Field Safety Notice

Reference : 202209-01

ThermoBrite Elite UL Compliance

Figure 1: Inner protective covers to be installed on ThermoBrite Elite instrument

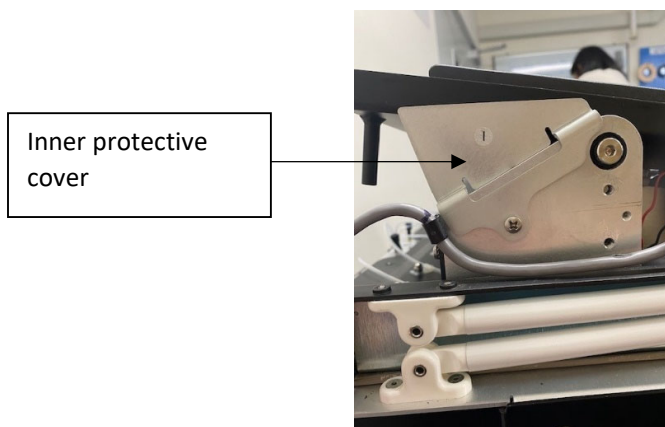
A potential crush/pinch hazard has been identified if a user places their hands between the drip tray and support bracket of the ThermoBrite Elite instrument while the instrument is operational. This does not meet the requirements of Section 7.3 of the IEC/UL 61010-1 standard. To fully comply with the standard, inner protective covers need to be installed on the instrument.

- Replace the thermal cut-out switch in the ThermoBrite Elite instrument and;
- Add inner protective covers.
